# Access Audit Final Site Report

**McDonald Field**  
**200 W Camp McDonald Rd**  
**Prospect Heights, IL 60070**

Prepared By  
**WT Group**

### Finding: 3

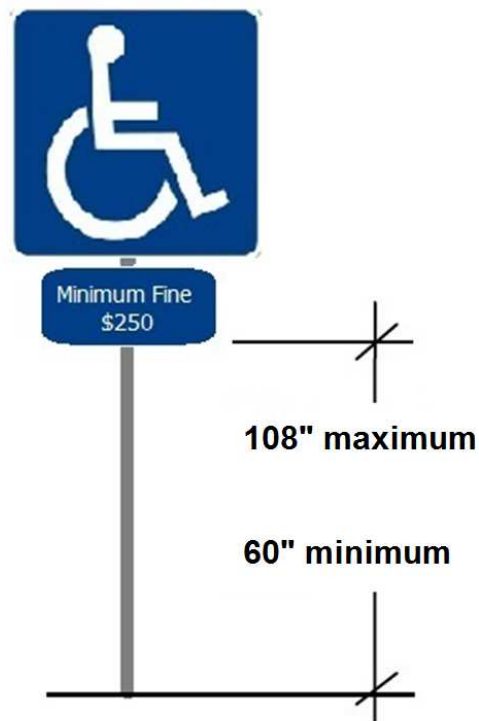
The parking sign is mounted too low.

signs low at 54" and 56"

Raise existing accessible parking signs so lowest end of bottom sign is min 60" aff and max 108" aff

### Finding: 4

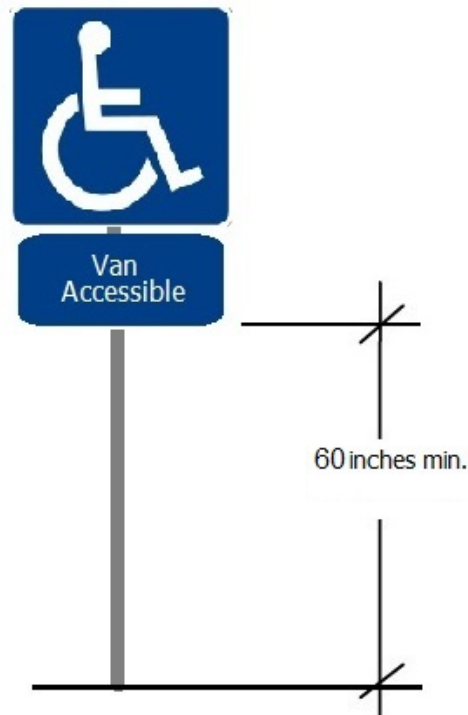
The van stall is missing a sign identifying it as a van accessible stall.

lacks van sign on van sized stall

Add one van parking sign to one accessible stall and ensure stall and access aisle are 11' and 5' or 8' and 8'.

### **Finding: 5**

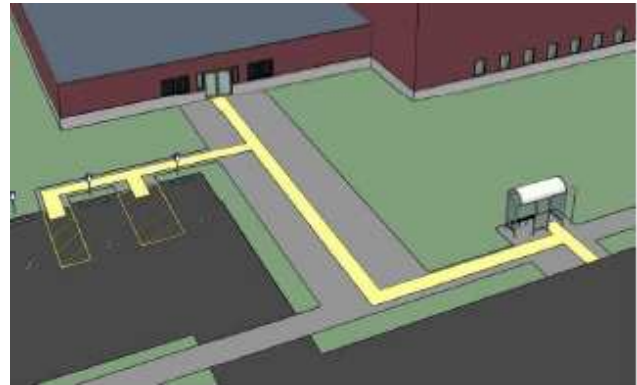
The access aisle is not located on an accessible route of travel to the accessible building entrance.

no accessible route

Assure access aisles connect to an accessible route once provided.

### Finding: 6

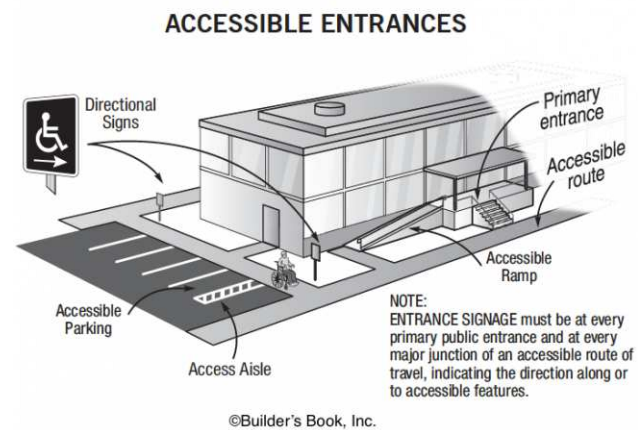
There is no accessible route to the element.

no route to affiliate  
group storage sheds  
(2)

Create an accessible route with crushed stone or other outdoor material from parking or walkway to element.

**Finding: 7**

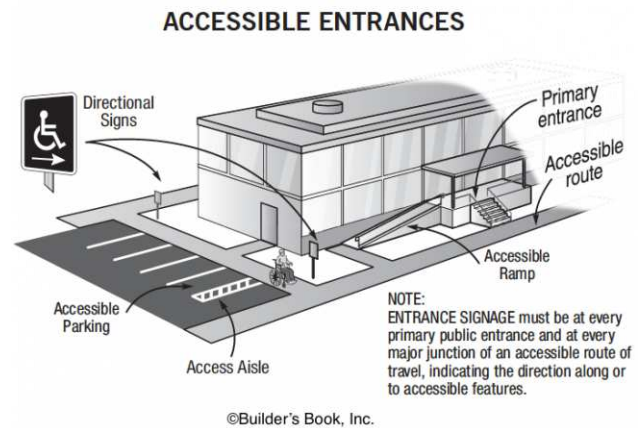
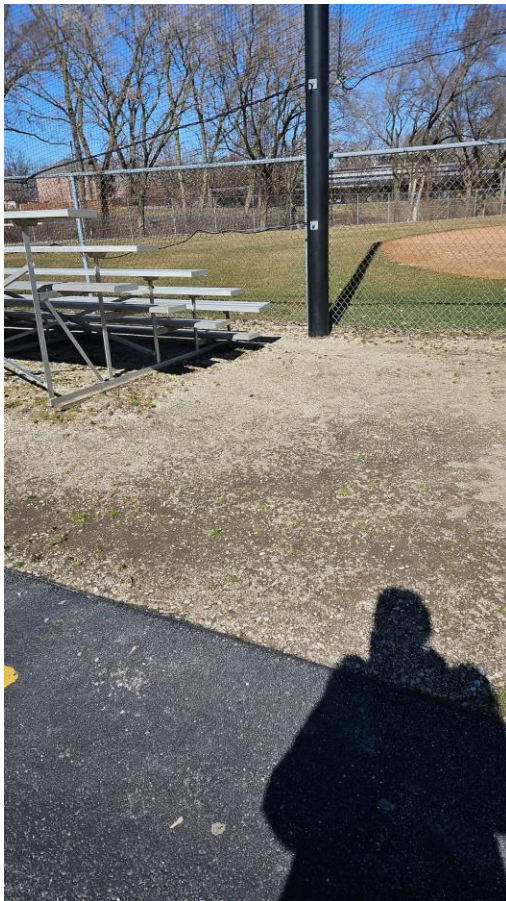
There is no accessible route to the element.

bleachers and dugouts  
lack route - dirt or  
grass

Create an accessible route with crushed stone or other outdoor material from parking to dugouts and bleachers on both sides.

### Finding: 8

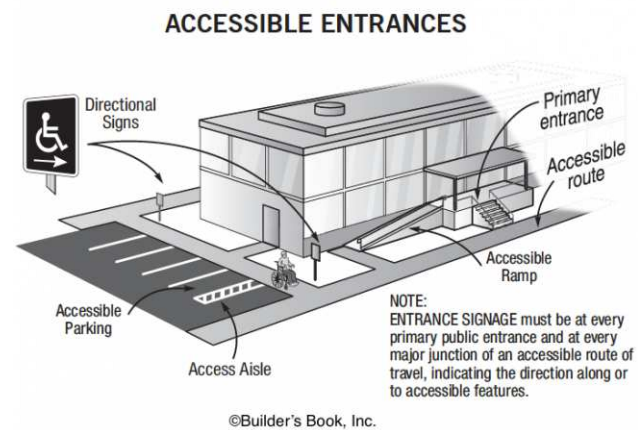
There is no accessible route to the element.

scorers table lacks  
route - grass

Create an accessible route with crushed stone or other outdoor material from parking or walkway to element.

**Finding: 10**

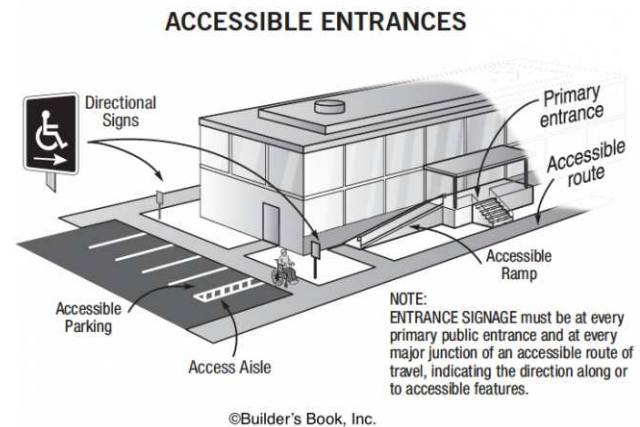
There is no accessible route to the element.

batting cage lacks  
route - grass

Create an accessible route with crushed stone or other outdoor material from parking batting cage.
